PLANNING AND INSPECTIONS DEPARTMENT

TO: Pinehurst Historic Preservation Commission
FROM: Alex Cameron, Senior Planner
DATE: 7/18/2019
SUBJECT: Staff Approvals of Minor Work

STAFF APPROVALS REPORT for LOCAL HISTORIC DISTRICT
July 25, 2019 MEETING
06/16/19 TO 07/15/19

**HISTORIC PRESERVATION COMMISSION
REGULAR MEETING MINUTES
JUNE 27, 2019
ASSEMBLY HALL
395 MAGNOLIA RD.
PINEHURST, NORTH CAROLINA
4:00 PM**

Sheet Name: MODIFIED FLOOR PLAN
MODIFIED ELEVATIONS

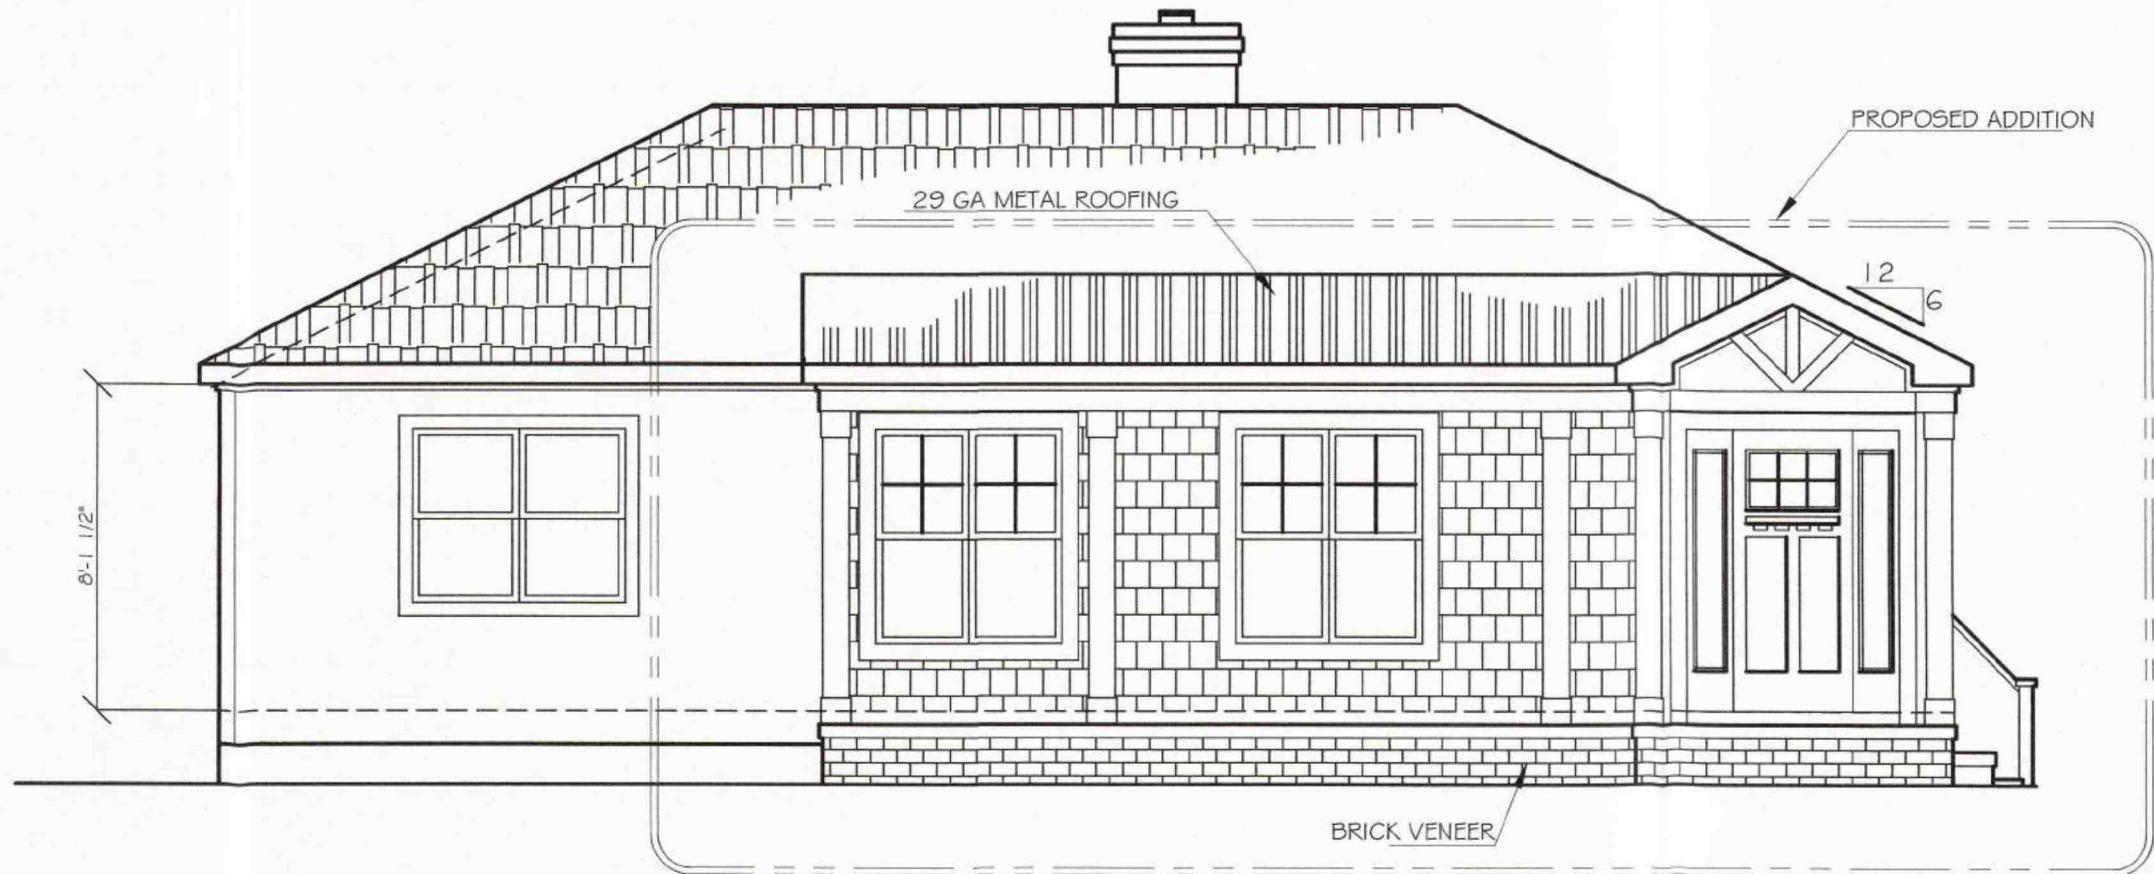
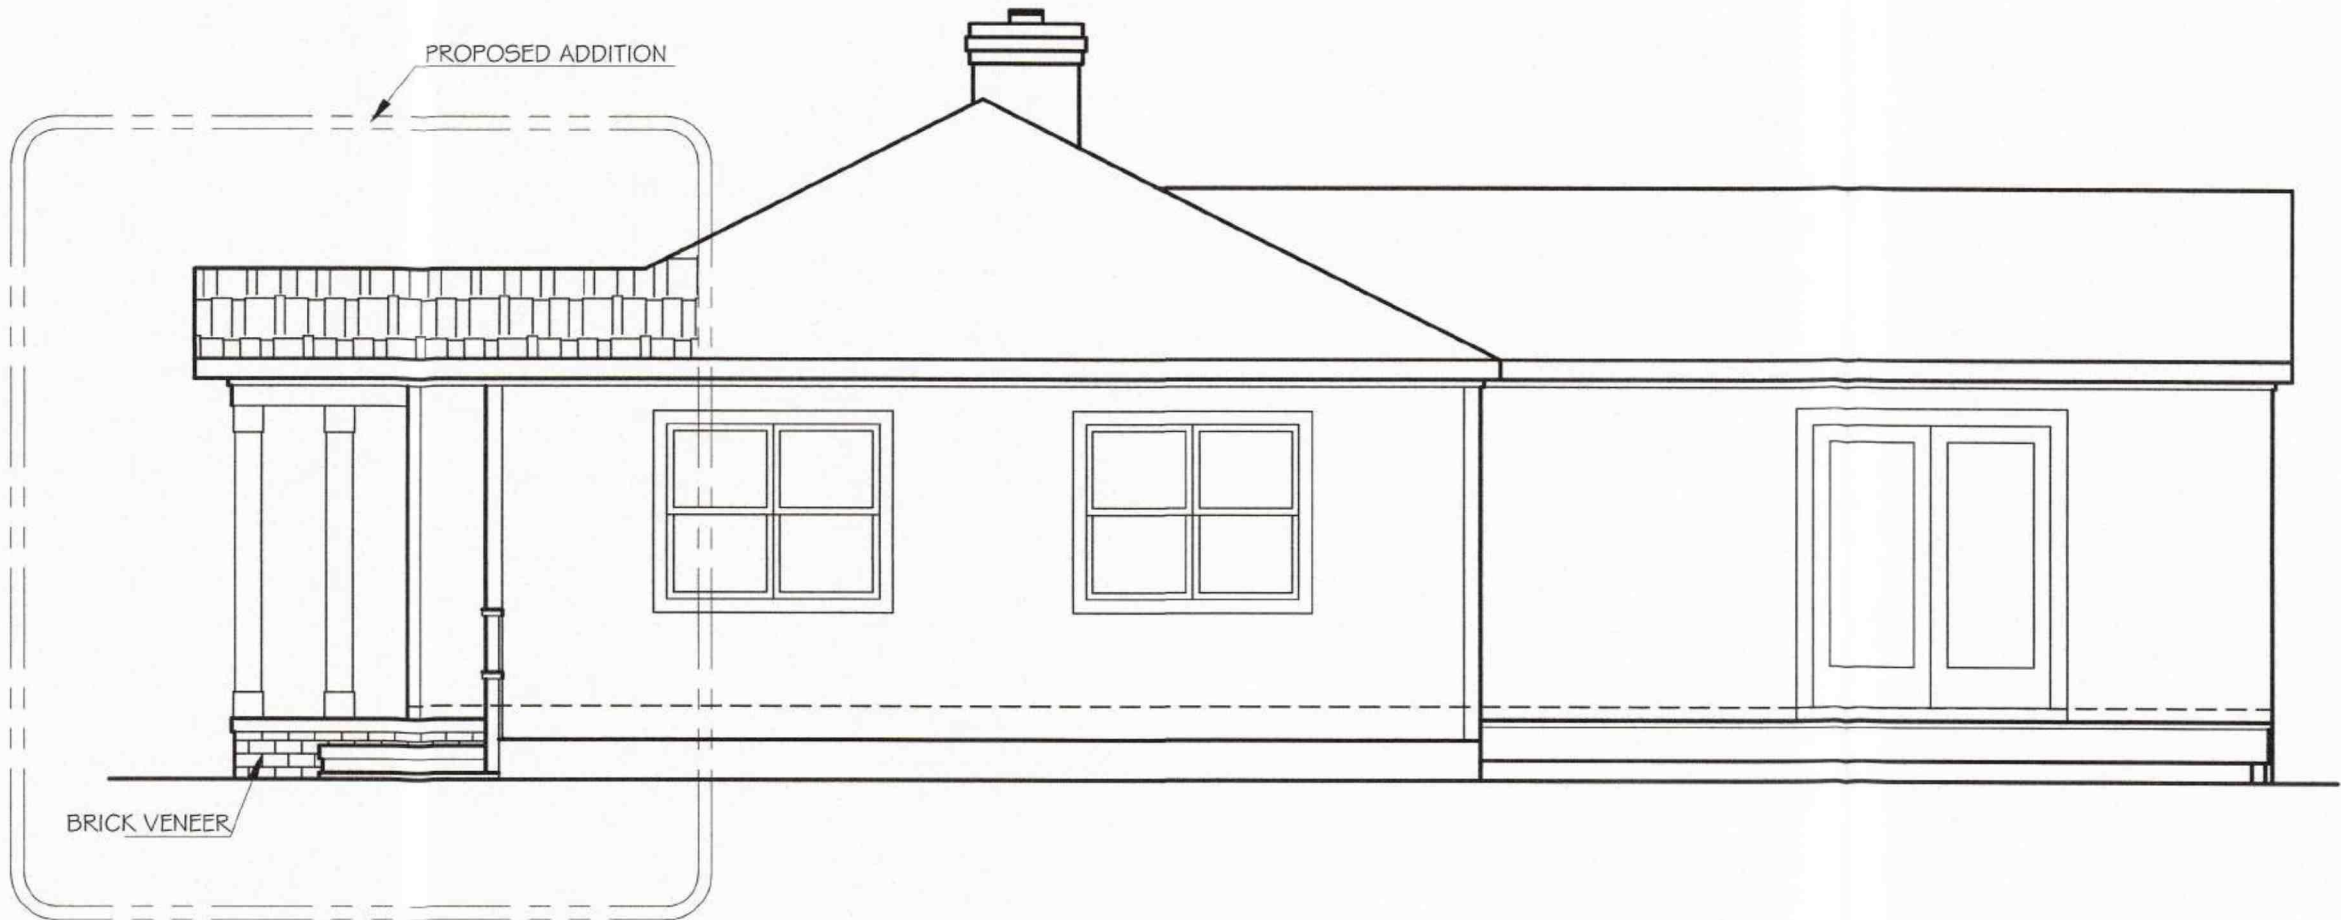
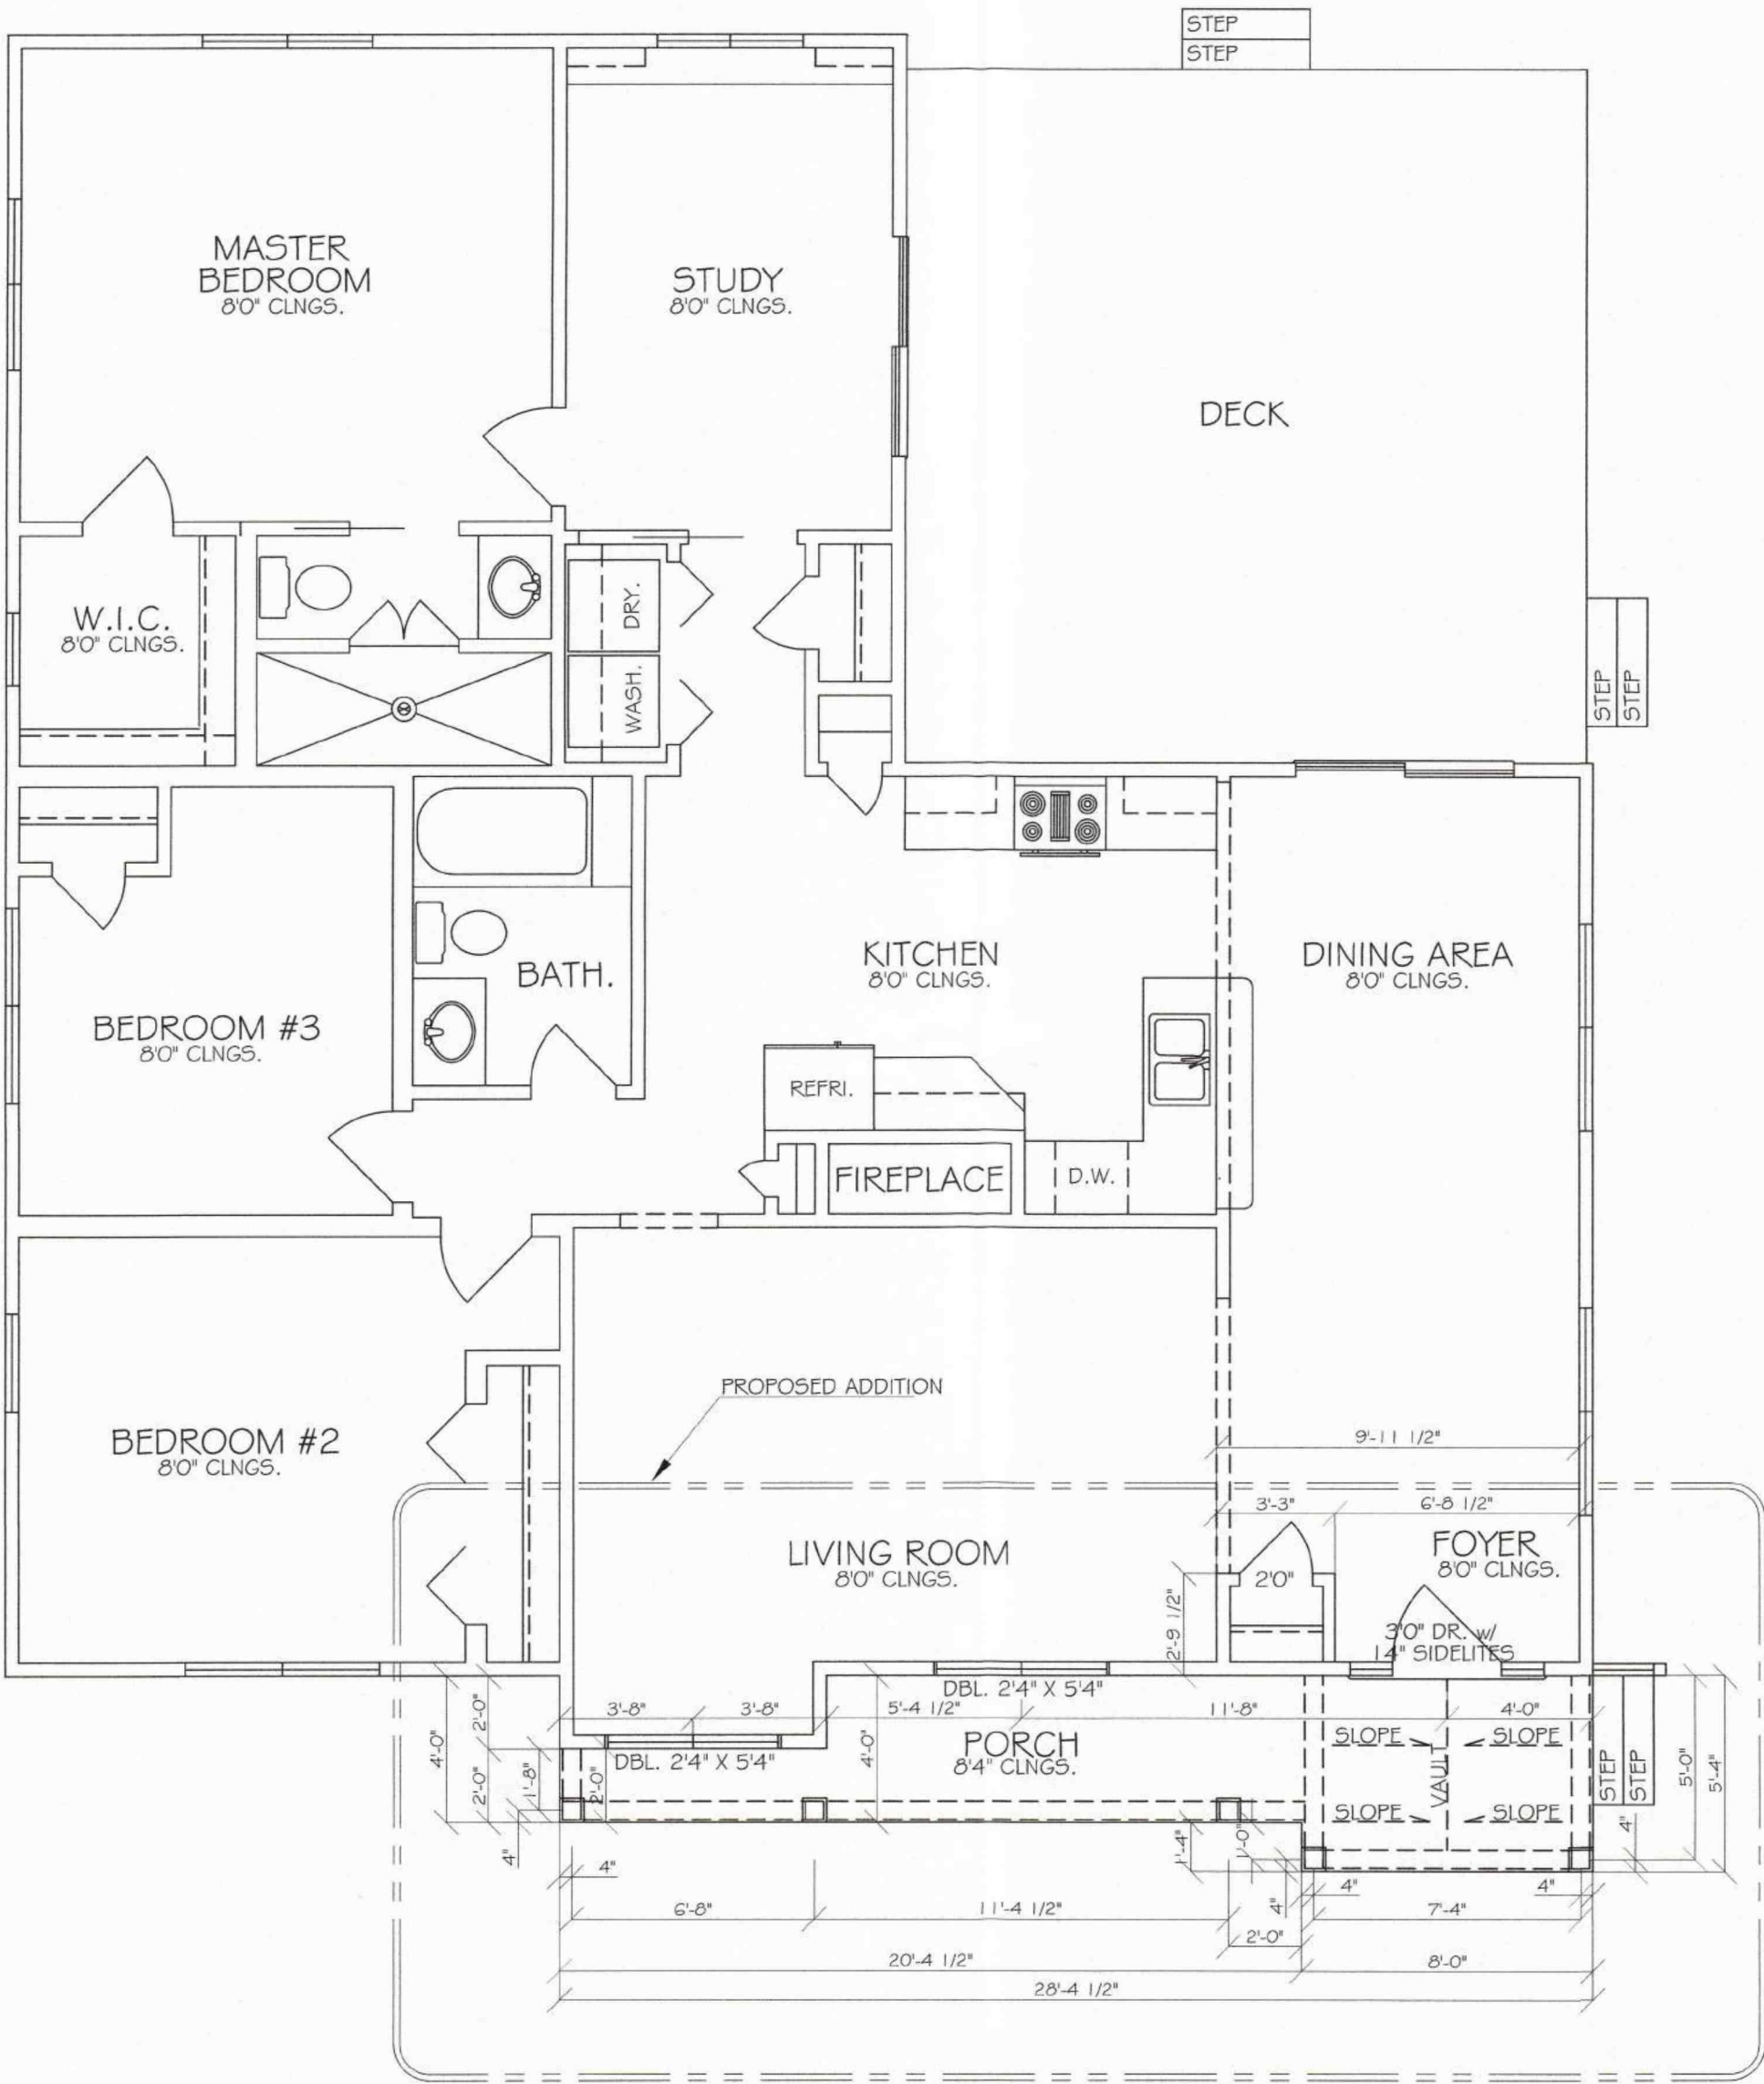
1. The applicant proposes to modify the front and side exterior of the home by adding a 28' wide porch addition, moving the door to the end on the right front of the building.
2. The materials are proposed to match materials and colors of the existing structure.
3. The foundation is proposed to be brick to match existing house.
4. A 29 gauge metal roof is shown on the plans for the porch roof. The plan also shows 30 year architectural shingles as roofing material.
5. The underside of the addition is proposed to be bead board.
6. The existing roof pitch is 6/12. The porch roof is proposed for 3/12.

1. The guidelines contain a design goal to replace materials in kind, matching the original in composition, dimension, size, shape, color, pattern and texture. The applicant proposes to match materials, including shingles, brick, paint color.
